Meghna Denims Ltd.

Building Information

Observations

Canopy structures around the stair

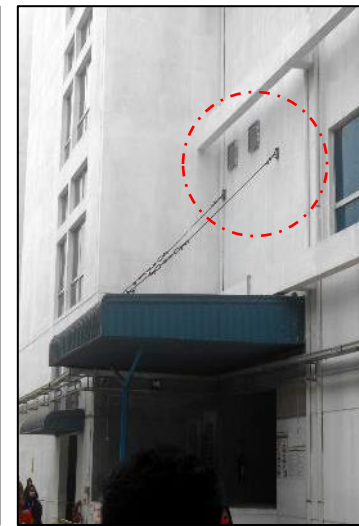
Missing drawing of the canopy structures

Drawing missing for the canopy structures around the stair area of RMG buildings. The connection of the canopy was not sufficient as well. Cable connection from wall was observed for some canopy.

Gap in the Connection to column

Item No.	Observation	Recommended Action Plan	Recommended Timeline
01	Building 1: Drawing missing of the canopy structures	* Building Engineer to survey the whole structure and prepare accurate as-built drawings.	Within 6 weeks.
02	Building 1: Drawing missing of the canopy structures	* Assess the connection capacity	Within 6 weeks.
03	Building 1: Drawing missing of the canopy structures	* Carry out remedial works as per report recommendation if required.	Within 6 months.
04	Building 1: Discrepancy in the drawing	* Building Engineer to survey the whole structure and prepare accurate as built drawings.	Within 6 weeks.

Beam on drawing

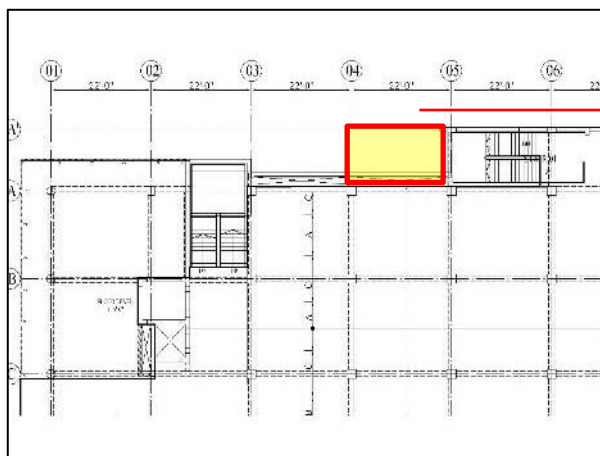
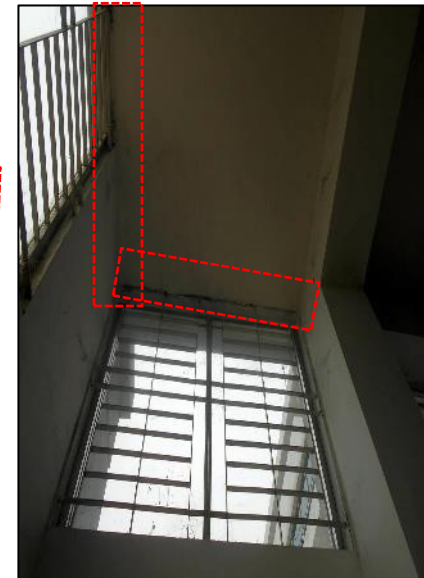
Discrepancy in the drawing

Tie beam elevation info was not available in the drawing. Some Beams on the edge was not found on site though these beams are shown in the drawing. 1st floor slab layout needs minor modification

Beam missing on site

Slab layout on load plan of 1st floor

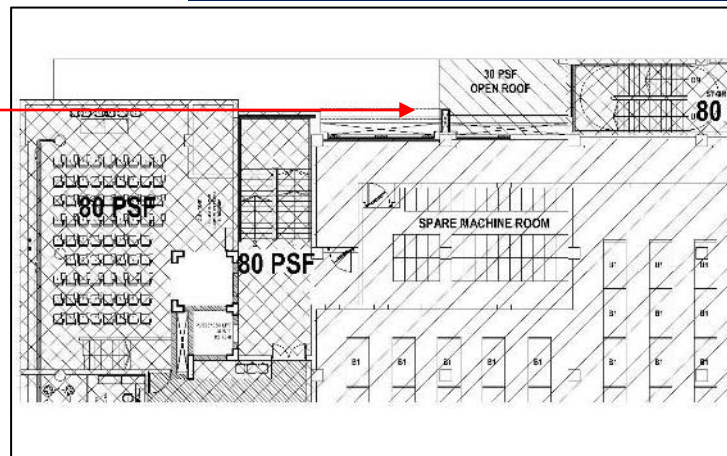
Extra slab on 1st floor

Support columns of the water tank

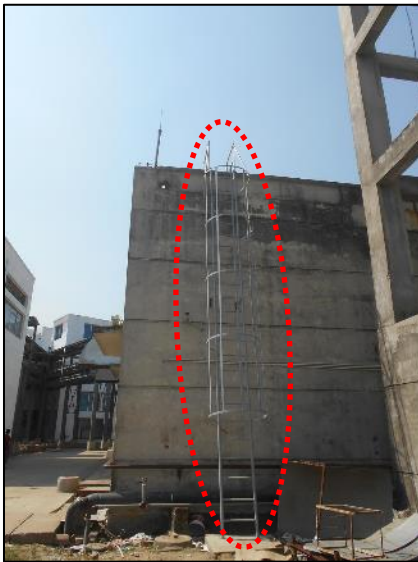
Free standing water tank without any restrain

Free standing water tank without any restraint was found on the ground floor. Free standing water tank may susceptible to damage structural components if any vertical load (EQ) incurred.

Item No.	Observation	Recommended Action Plan	Recommended Timeline
05	Building 1: Susceptible to injury due to gap in expansion joint	*Building Engineer to survey the whole structure and fill the gaps with appropriate materials.	Within 6 weeks.
06	Building 1: Exposed reinforcements on the roof	*Building Engineer to remediate the corroded rebar.	Within 6 months.
07	Building 4: Free standing water tank without any restrain	*Building Engineer to fix the support so that the water tank can withstand vertical loading.	Within 6 weeks.
08	Building 4: Free standing water tank without any restrain	*Carry out remedial works as per report recommendation if	Within 6 months.

Current roof of factory building

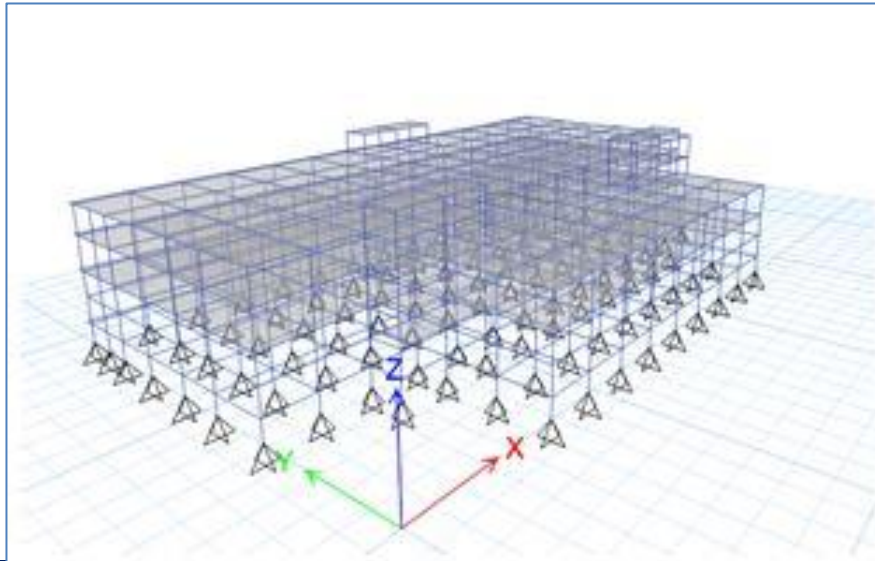
Possible vertical extension

Currently the building is 2 storied. Building owner has a future plan to extend the building vertically up to 3 storey. They have prepared DEA considering 3-storied building. Factory engineer is required to review the Detail Engineering Assessment considering BNBC provision prior to any extension work.

Item No.	Observation	Recommended Action Plan	Recommended Timeline
09	Building 5: Insufficient parapet wall on roof	Building Engineer to provide parapet walls.	Within 6 weeks.
10	Building 9: Damaged beam on stair	Prior any extension work, prepare a Detailed Engineering Assessment (DEA) report of the building and submit. Otherwise, provide consent letter.	Within 6 months.
11	Building 10-11: Possible vertical extension (Washing & Storage building)	In case of extension, factory engineer require to submit the Detailed Engineering Assessment report following BNBC requirements.	Within 6 weeks.
